ADDENDUM NO. 3

DATE: May 4, 2022
FROM: City of Grand Junction Purchasing Division
TO: All Offerors
RE: Tiara Rado Force-Main Replacement Project IFB-5066-22-DH

Addendum #3 | Tiara Rado Force-main

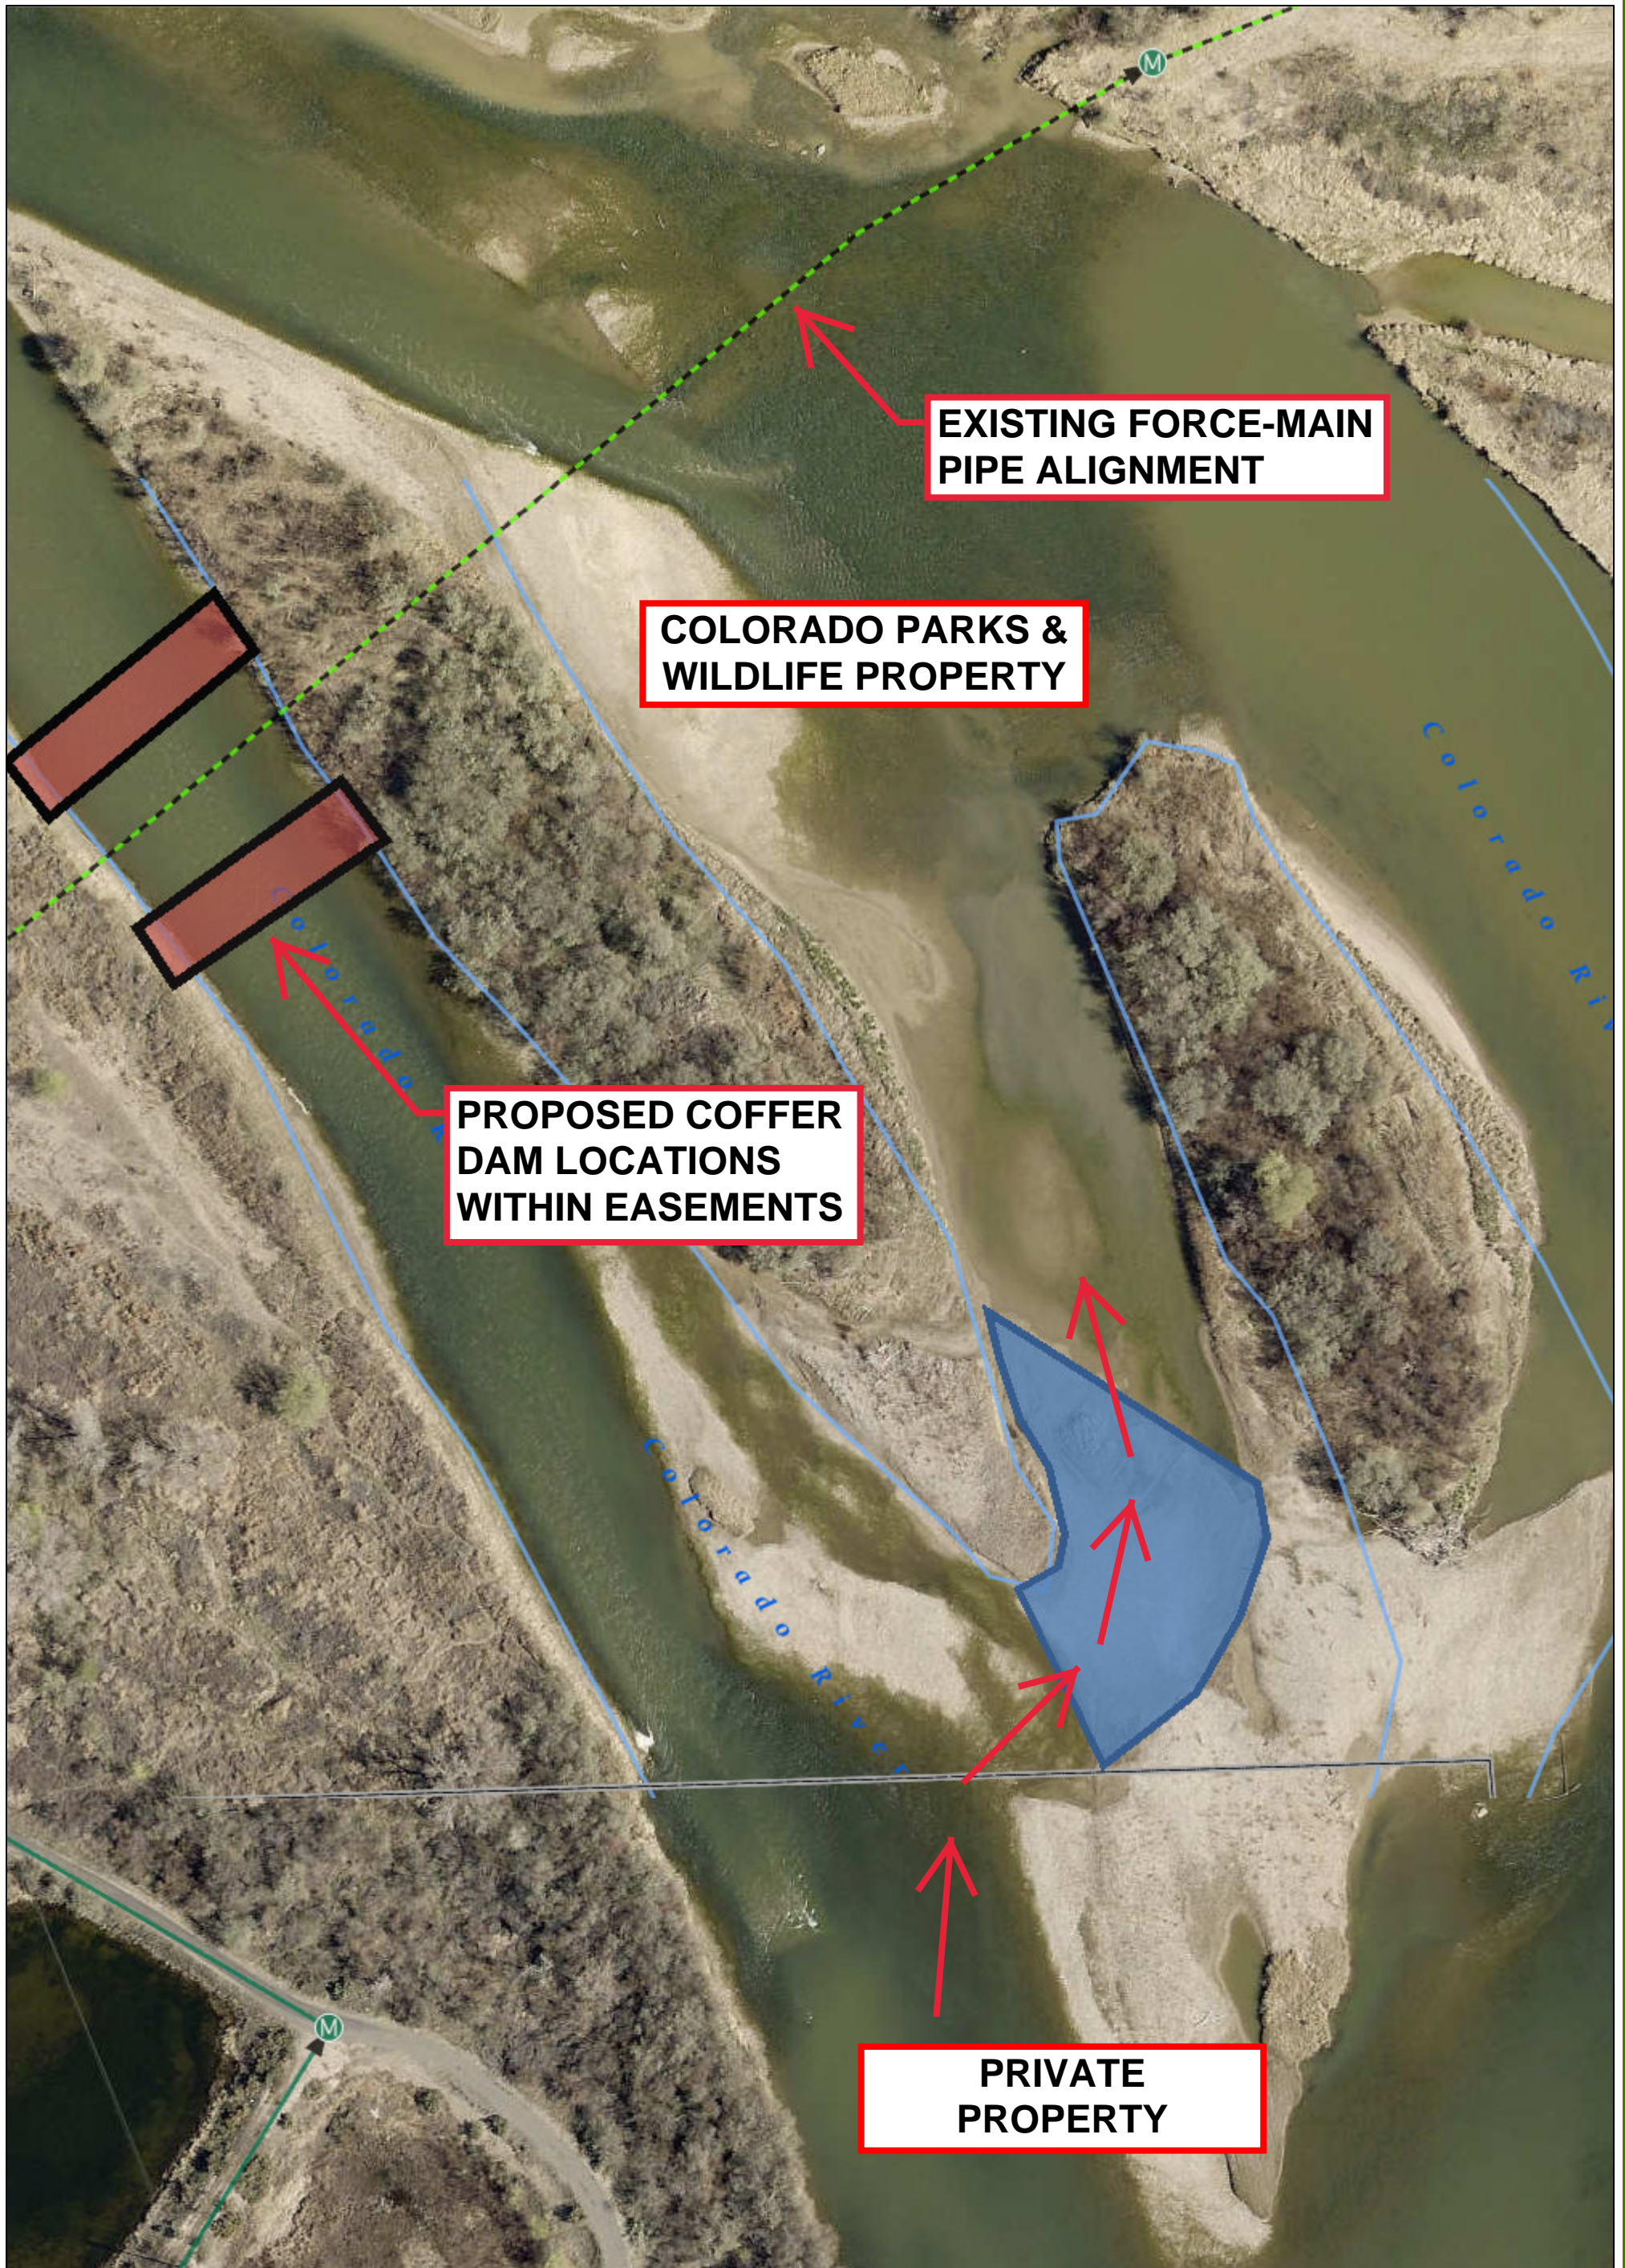
1. Q. Concerning coffer dams, the south channel appears to be the main channel. Are we confined to the south channel easement? Would the Contractor have the opportunity to move the coffer dam upstream (southeast) to help divert the river water to the northern channel?
 - A. *The City reached out to the Colorado Parks and Wildlife (CPW) for assistance in answering these coffer dam questions. Any major deviation of the coffer dams from the approved access and temporary easement boundaries would require the City to obtain additional temporary easements. Acquiring additional easements and getting approval from CPW's Real Estate Dept. is a time-consuming process that the Project doesn't have time for. The Project is confined to using the easements limits the City acquired within the river channel for coffer dam location and construction.*

The main issue with locating the coffer dam further upstream to divert the river water to the northern channel is that the coffer dam would be located on private property.

To help with diverting river water to the northern channel, the CPW would be okay with the Project grading the existing gravel bar between the two river islands to create a channel to help divert the river water to the northern channel. This gravel bar is located on CPW property. The exhibit attached to Addendum #3 helps illustrate where this gravel bar is located and how the water can be diverted to the northern channel (highlighted with blue shading). The City believes that access to the gravel bar area shown in the attached exhibit can be along the banks of the main river island. The river flows in October and November 2022 will be a lot lower than the flows currently in the river and the island banks can be used for access to the gravel bar.
